##### **Application of the Convention – Vehicles with sliding sheets**

### **Vehicles with sliding sheets**

#### **Note by the secretariat**

##### Sketch No. 10.1

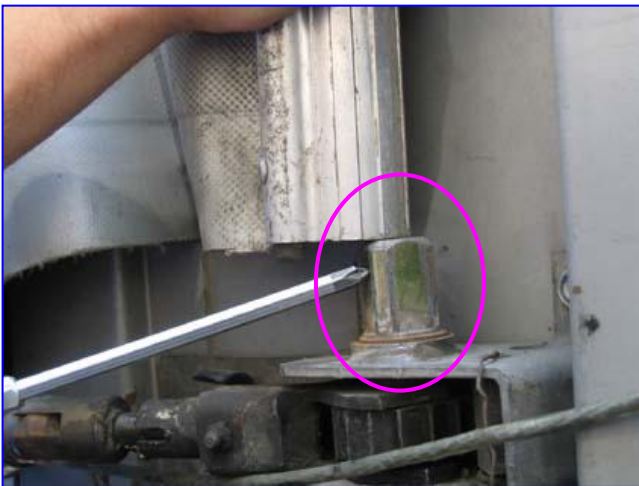
The place where the draw-bar/tensioning bar connects to the square axle exiting the ratchet system **MUST** be covered and protected by a metal-plate, and this plate **MUST** be secured by the rope/TIR wire. The square axle exiting the ratchet system is normally between 15 and 20 mm high and it is possible to force the draw-bar/tensioning bar off the axle – a big screwdriver and a few pushes is enough.

**LEFT:** Ratchet release system – note the height of the square axle: 20 mm only!

**RIGHT:** Alost similar ratchet system – lock system for the handle secured by the rope/TIR wire + metal-plate covering the connection of the draw-bar/tensioning bar secured a system of eyelets, TIT rings and the rope/TIR wire.

(b) Gearbox securing

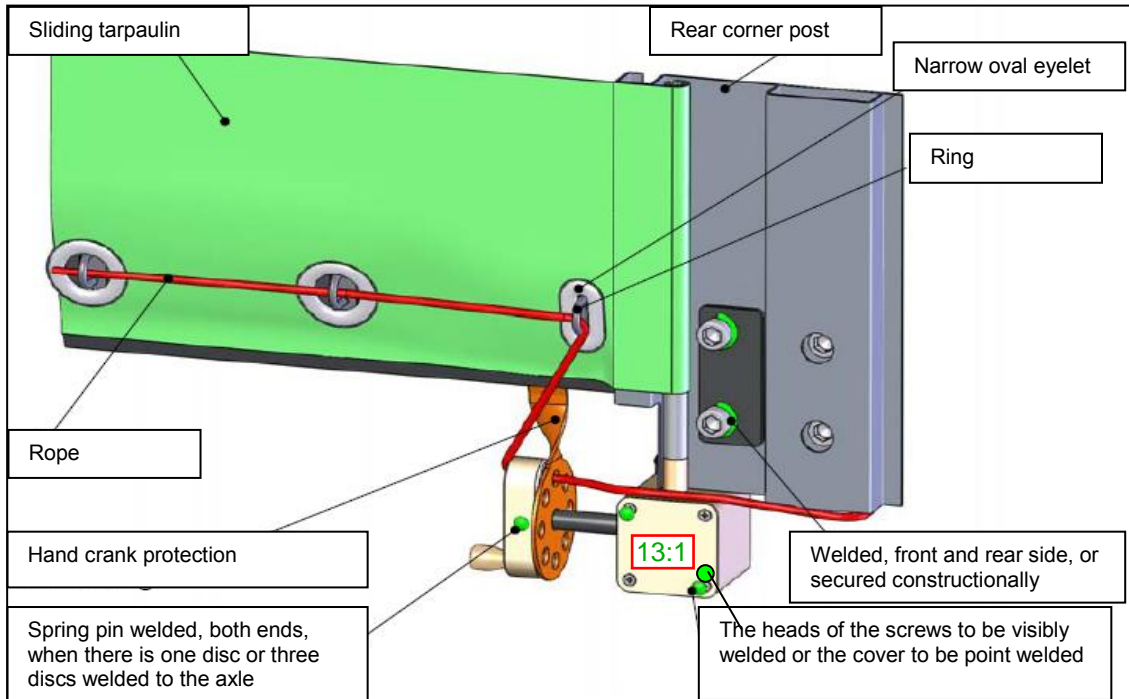
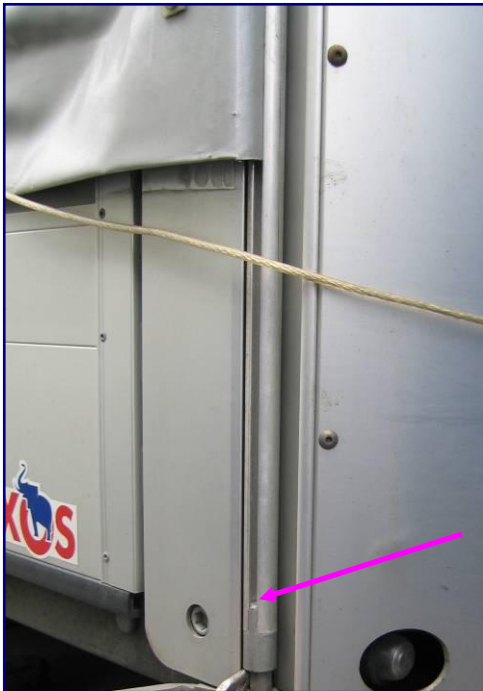
Arrow pointing at a single plate mounted in order to prevent rotation of the hand crank. It is quite easy to force this single plate away from the handle making 6-8 mm space between the hand crank and the plate – which makes it possible to rotate the handle. It is ALWAYS possible to find extra (loose) 15-25 cm of rope (TIR-wire), especially where the customs seal is affixed. The system preventing the handle to be rotated MUST consist of a 3-plate system – as illustrated by CLCCR (WP.30 – 2007 presentation).

Oval shows the “brass” end-piece connection to the square axle from the gearbox and the visible end (app. 6-8 cm) of the “hollow” draw-bar/tensioning bar. The sheet/tarpaulin can easily “slide” up-down inside the draw-bar.

It is quite easy to lift the draw-bar off its base – also if it is pulled tight. The most difficult part is to reinstall. Often a special prepared pipe wrench or tong is required, and I have only once seen this adapted wrench unfortunately I have no photo available. If the slid is visible it is possible to use the top of the end piece to force the draw bar back in place (arrow).

It is not possible, due to the fact that the crank protection is welded to the chassis and the gearbox with the shaft is also welded. These are two fixed points which has the effect that it is not possible to force this 4mm (thick) single plate more than 2.5 mm away from the hand crank.

- This is not a TIR trailer!
- The sheet is fixed to the bar and it is not possible that the sheet is moved up or down the bar.
- Anyway, if the sliding sheet is tight in horizontal direction, it is not possible to move the tarpaulin up or down.

This text is correct for systems shown in the pictures - but these trailers are NOT TIR - trailers.

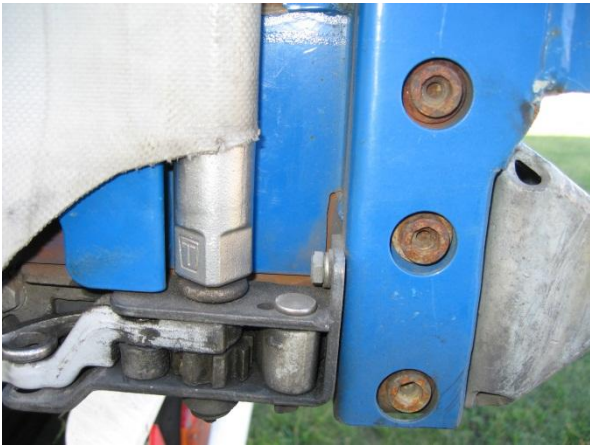
Picture of an end-piece with square lower part. This end-piece (and draw-bar) can easily be rotated by using a normal wrench. Also the opening where the sheet is inserted in the draw-bar is accessible. Note the gap between the sheet and the end-piece (app 2,5 cm) – the sheet can slide this distance inside the draw-bar.

No, due to the fact that the sheet is affixed to the draw bar, it is not possible to slide in the draw-bar.

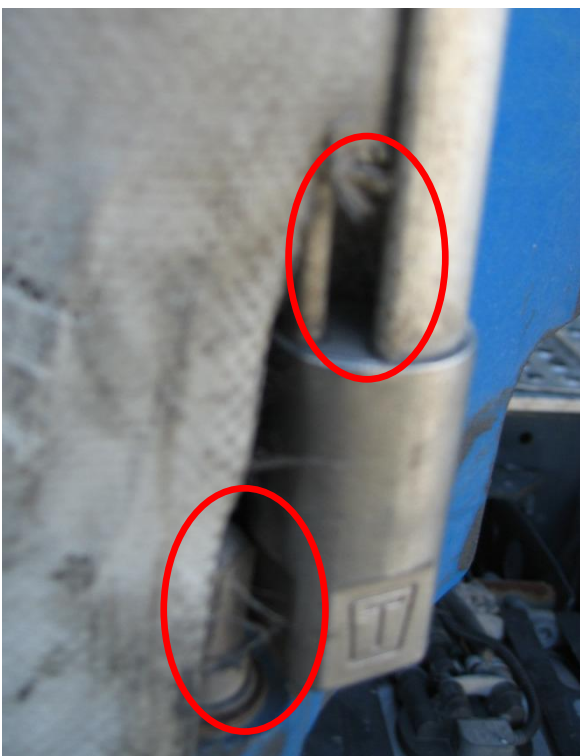
Same type of end-piece – located at the REAR of the trailer.

Note the slid / space between end-piece and sheet – it is equal to the height of the square base for the draw-bar. This allows for movement the draw-bar – up/down.

This trailer is not for TIR transport!

**Sketch No.10.2**

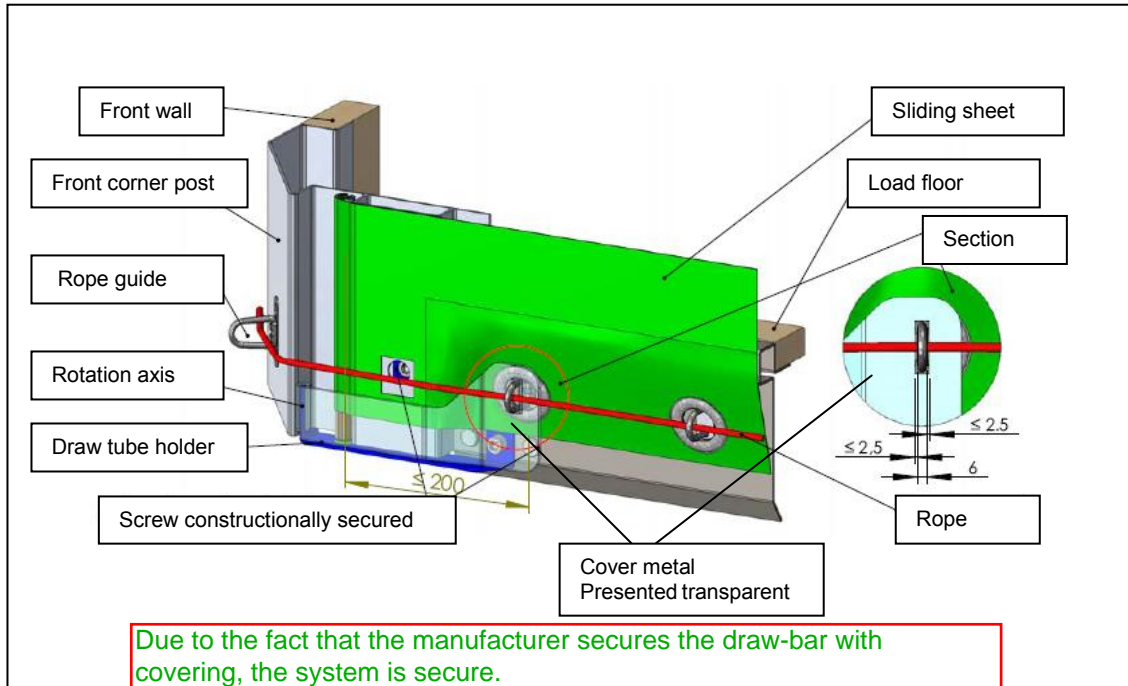
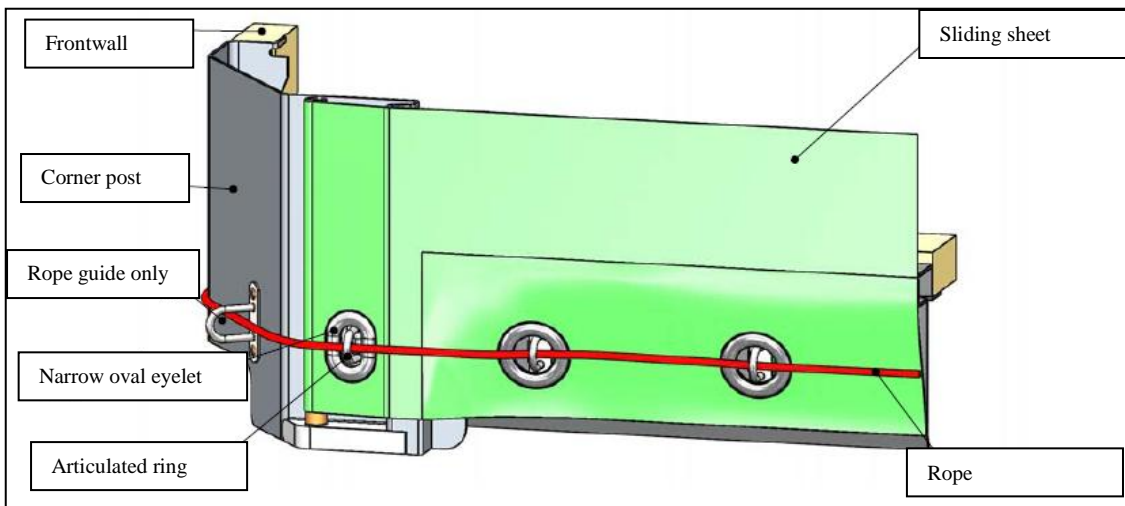
The system above I consider being secure – due to the metal plate covering the base and end-piece of the draw-bar. There is no access for tools needed to lift off the bar.

(b) Narrow oval eyelet, anti lifting system for the tensioning tube

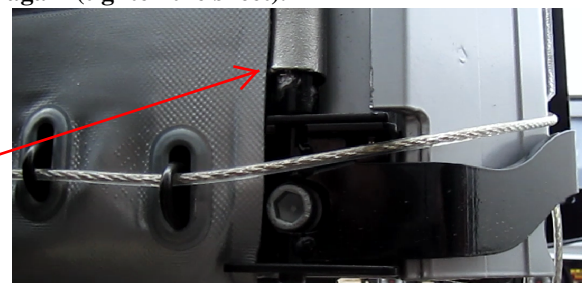
**NO**

Although an eyelet/TIR-ring is located quite close to the draw-bar, I still consider this system to be non-secure. There is access to the base for the draw-bar – and bearing in mind that the sheet can slide inside the hollow draw-bar the bar can be lifted (forced) off the base. Again the difficult part is to put it nicely back again (tighten the sheet).

- The sheet is fixed to the hollow draw bar. It can NOT slide inside the draw bar.
- The narrow oval eyelet makes it impossible to lift up the draw bar from base.
- This picture shows an example. It was not possible to lift up the draw bar. To put it from the base you need additional 15mm.
- With this test the draw bar was already damaged.

Sketch 10.3

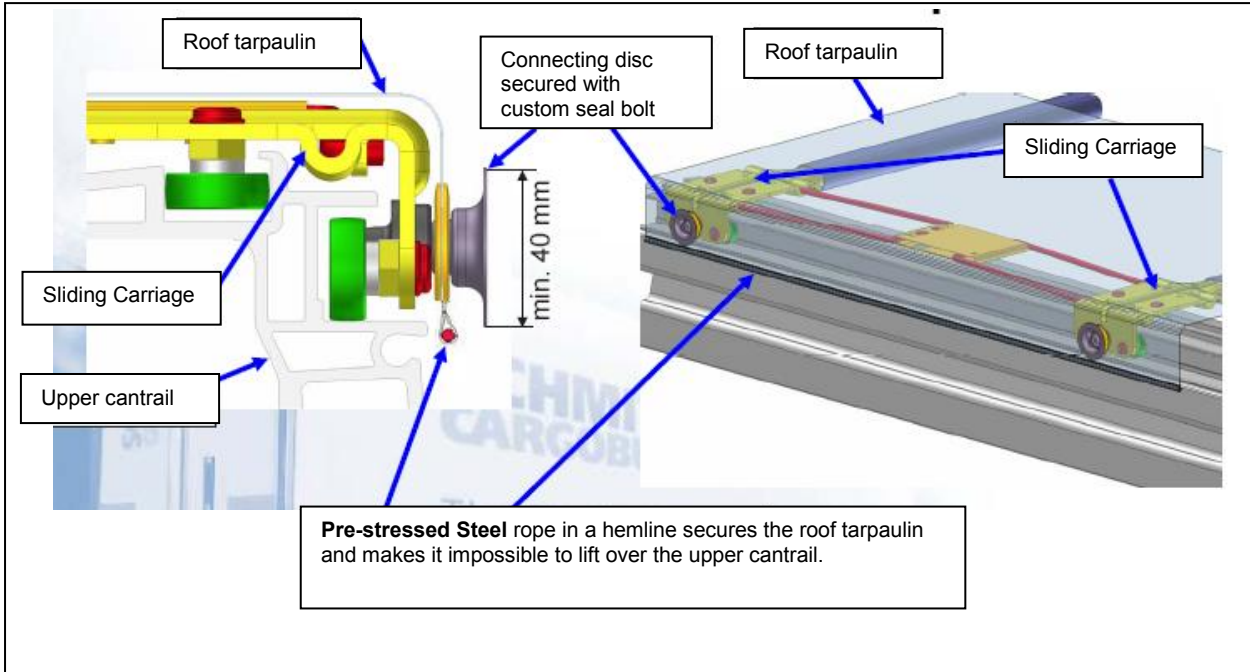
Most sliding roofs are seen having only wheels at the side of the carriage – and this new system is an improvement. The carriage is significantly stronger and better due to the system of wheels both at the upper part and at the side of the cantrail.

However it is a **MUST** that it is not possible to put a hand through and behind the sheet (behind the pelmet covering the sheet along the side of the vehicle). The system above shows the normal distance between the upper crossbars (main carriages) – no additional rollers/bearings mounted, and I am convinced that it is possible to get a hand inside the vehicle. Again I have to refer to the vehicles presented by CLCCR – on this trailer two additional wheels/bearings is mounted to the sheet at the upper cantrail – see photo below.

**Green = Main carriages – seen from outside under the pelmet – distance app. 60 cm.  
Purple = TWO additional wheels/bearings.**

**The two additional wheels/bearings are preventing a hand to pass.**

**This additional system must most likely also be mounted on the roof tarpaulin/sheet – just over the hemline. On the sketch it is rather difficult to see the actual structure of the upper cantrail and therefore not possible to establish the wideness of the cantrail. Along the side an overlap of the solid parts is required (normally/standard is 15 cm) – ¼ of the distance between the rollers/wheels). The same overlap should also be in place at the roof as the cantrail is considered being “a solid part of the vehicle”.**

The custom security of the sliding roof is guaranteed if a pre-stressed steel rope, embedded in a hemline, is fixed. This steel rope is fixed to the front and rear of the container. The tractive force as well as the connecting disc on each sliding carriage, makes it impossible to lift up the hemline with the steel rope above the upper cantrail.

The distance of the carriages is chosen such that the tension of the steel rope in the hemline prevents a complete reaching above the upper cantrail.
